Project: IEEE P802.15 Working Group for Wireless Personal Area Networks (WPANs)

Submission Title: comment and resolution about CID 33, 58, 34 and 59

Purpose: Contribution to IEEE 802.15.7 TG-VLC

Draft D6 (Subclause 5.1.7.4.1, page 46) Sentence

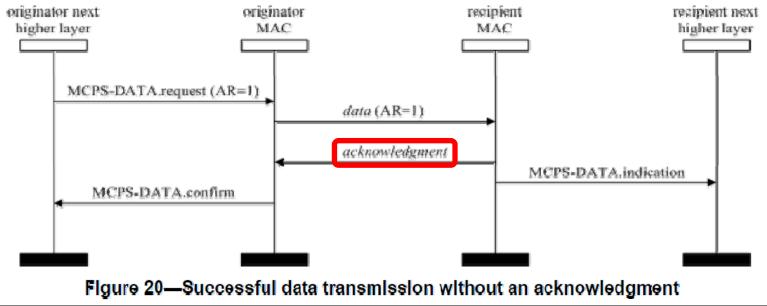
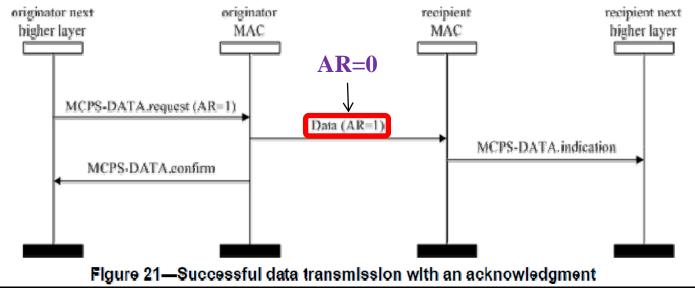
- Comment 33: Figure 20 has the title of "Successful data transmission without an acknowledgment", but the actual figure has AR=1, and sh ows an acknowledgement. I believe the wrong figure is here
- Comment 58: Text is about "without ACK". Buth the figure 20 describes about with ACK
- Comment 59: In "without ACK" case, AR should be "0". But AR=1 in figure 21.

- Comment 33: Put in the correct figure
- Comment 58: Change figure 20 with figure 21
- Comment 59: Change "AR=1" to "AR=0" in figure 21

- Change figure 20 with figure 21
- Change AR=1 to AR=0
 - Subclause 5.1.7.4.1, page 46, line 26
 - In this case, the originator transmits the data frame with the Acknowledgment Request (AR) subfield of the frame control field equal to zero.
